SUBMISSION ON A RESOURCE CONSENT APPLICATION THAT IS SUBJECT TO LIMITED NOTIFICATION BY THE KAPITI COAST DISTRICT COUNCIL
Pursuant to section 96 of the Resource Management Act 1991

Application Number:	RM190125
Applicant:	Housing New Zealand Ltd
Proposal:	To undertake a two lot residential subdivision that does not meet the shape factor, minimum and average lot sizes, requires consent for contaminants in soil and land use consent for the construction of two dwellings prior to the certification of the subdivision that do not meet the permitted activity standards for car parking, water demand management and accessory buildings encroaching the require yard setbacks
Legal Description(s):	Lot 62 DP 23300, 35 Kaitawa Crescent, Paraparaumu

Opposition to the RM190125 35 Kaitawa Crescent Paraparaumu

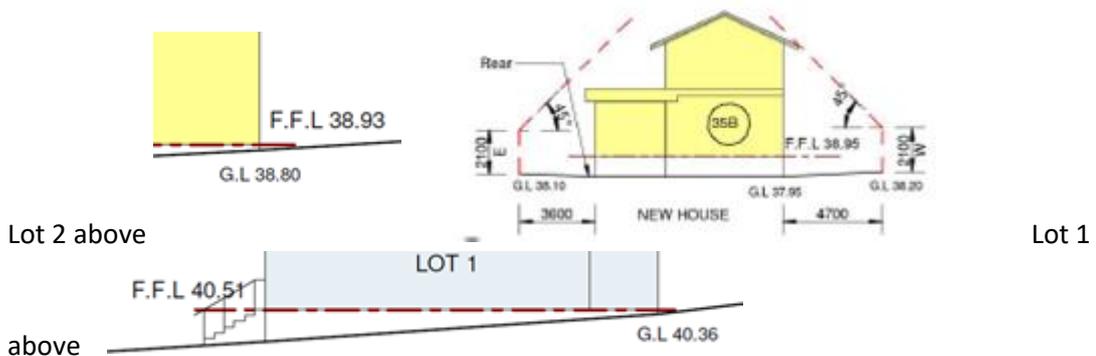
The foundation to ground clearance is wrong. The house height will need to be lifted, or the house position will need to be shifted, to comply with daylighting requirements. Please see the below copied diagrams from the RM190125 showing ground clearance for a concrete foundation, whereas the building consent plans are for a timber floor construction (shown to me on screen in council – I am still waiting on copies of the full working drawings, which I have requested from KCDC.)

- The house is close to touching the day lighting angle and the foundations are shown with base boards.

- As per the building code, the underside of the floor joist to the ground level needs to be a minimum of 450mm. (175mm minimum to the bottom of the cladding) the information provided shows ground level to the finished floor at 130mm for lot2 and lot one at 150mm both non-compliant, if site cuts are to be carried out to drop the ground level this will need to be calculated and provided as part of the resource consent, this would need to include the sloping car part areas

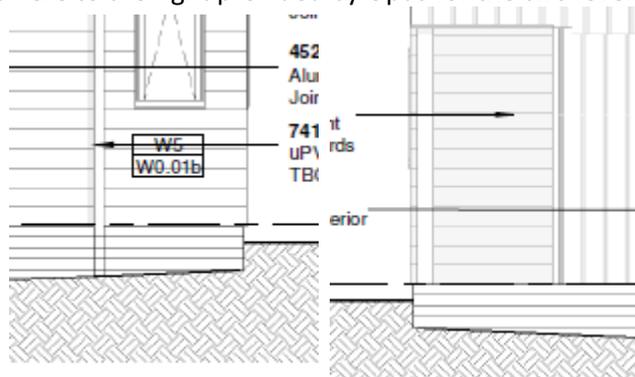
- This is a sloping site- surface water needs to be redirected away from the foundations. Where is this information please?
- The below drawn images from the RM190125 are non-compliant and don't support timber floor clearances.

- Both BC190722 & BC190676 provided by KCDC are National Multiple-use approval establishes that the plans and specifications to which it relates comply with the building code. However they are designed for a flat site and don't take into consideration the sloping site at 35 Kaitawa Crescent, which has a 3.2mtr fall from the top boundary fence to the bottom fence hence my concerns mentioned above

- The details here to the right provided by Opus for the two level home are drawn being non-
